Solicitation No.: Bid 22-29

Solicitation Name: Furnish and Installation of Bogen Nyquist E7000 Series Paging System for CSLA

Subject: Addendum Number 1

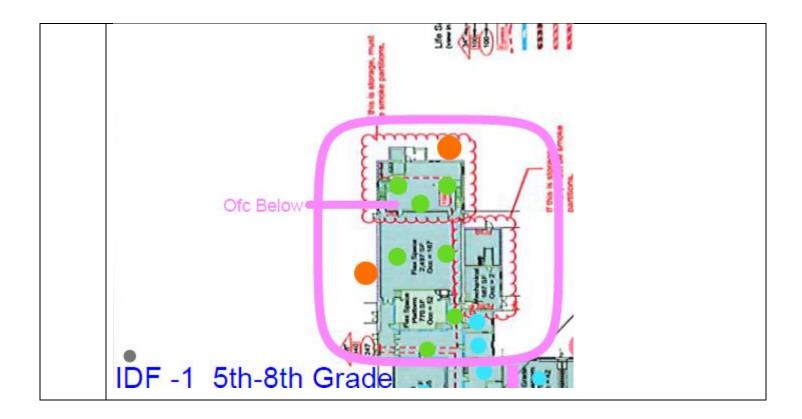
4.	 4. Awarded bidder will be responsible for providing all fire stopping material and sealing penetrations where required, as the "final" installer on the site. Including all cable tray penetrations into the MDF/IDF
5.	 See pictured area below, can all be common, no need for the Ofc below area to be on its own port on a bridge device. This was pointed out during the walk thru at the STAGE area
